**VARIANCE BOARD OF ADJUSTMENTS
AGENDA
THURSDAY OCTOBER 21, 2021
5:30 PM**

RE: APPEAL OF THE HISTORIC PRESERVATION REVIEW COMMITTEE'S (HPRC) CONDITION THAT WAS PLACED ON THE CERTIFICATE OF APPROPRIATENESS (COA) FOR THE CLUB HOTEL AT 1601 COLORADO BLVD.

Jonah Hearne, Managing Member for 5340 Investments LLC (the Applicant and Owner), requests an appeal of the condition placed on the COA issued by the HPRC regarding the Club Hotel located at 1601 Colorado Blvd. The HPRC issued a COA with the following condition:

1601 Colorado Boulevard
Idaho Springs, CO

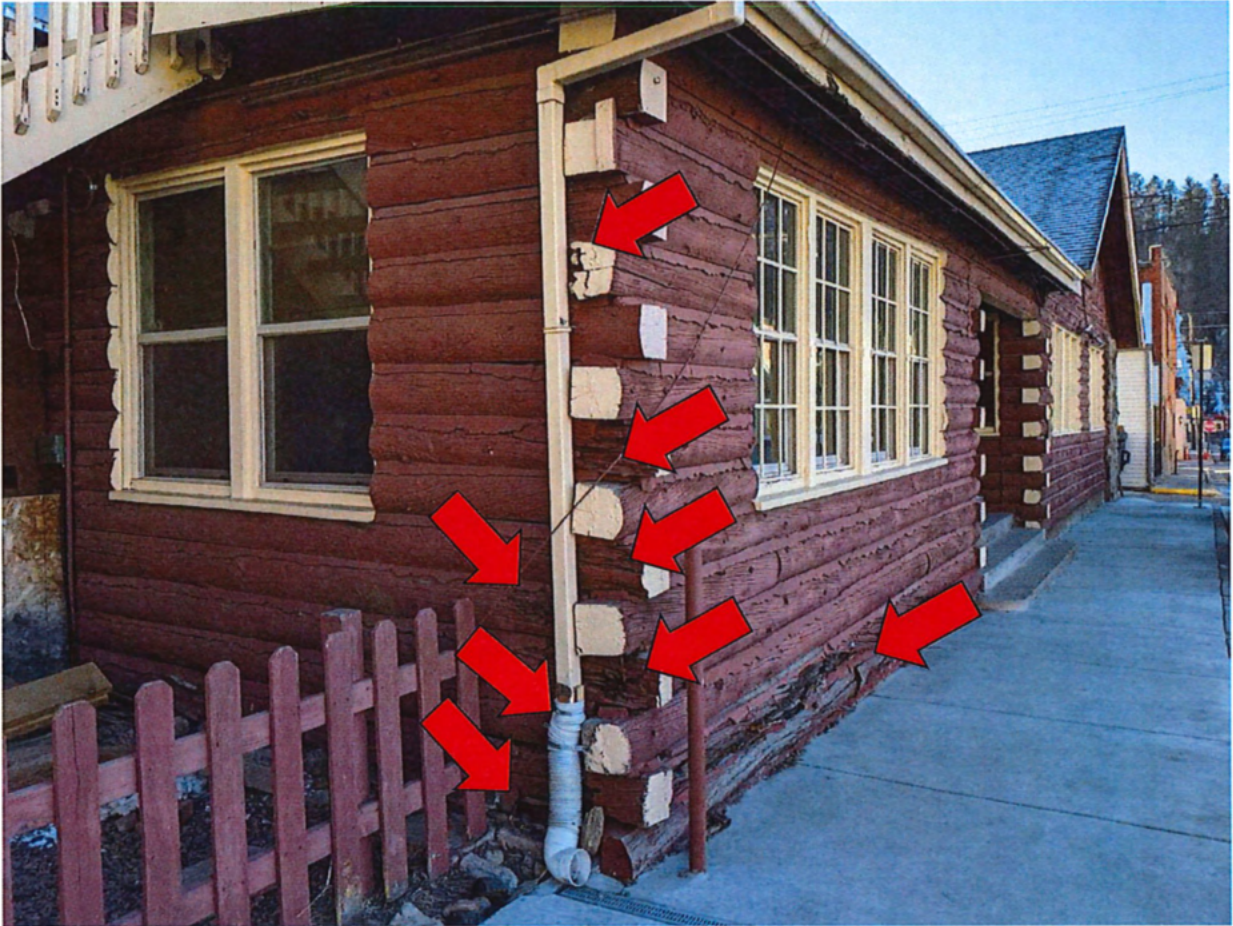
Repair and add window trim to match existing trim from original structure.

Remove slab siding, repair existing window trim, and paint.

Stabilize log construction.

NEW CONSTRUCTION REAR
8 LEFT SIDE ELEVATIONS

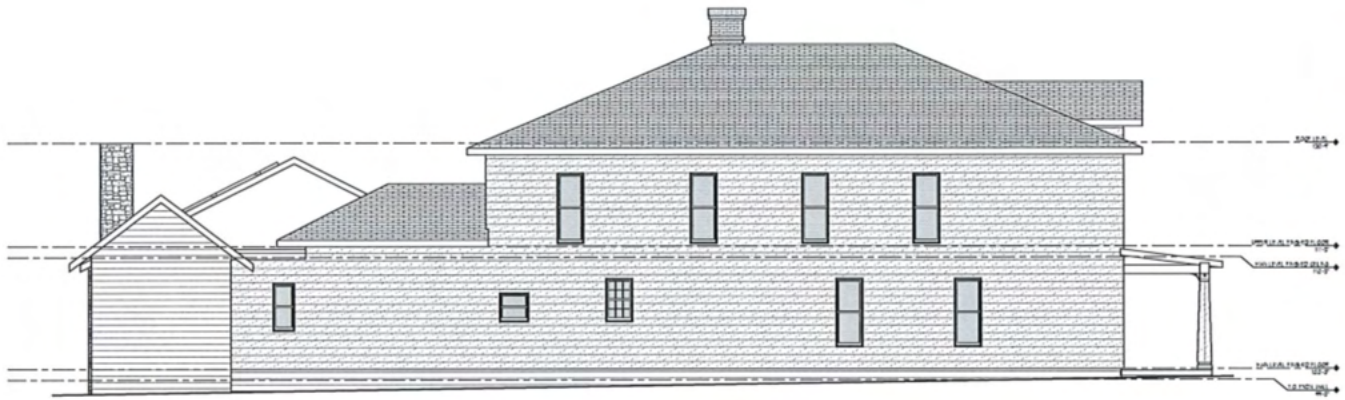
- Add doors to the patio on the south side alley for second floor and first floor building egress.
- Stabilize the log construction on the west and south side of the build. Cover with clapboard siding to match original house siding.
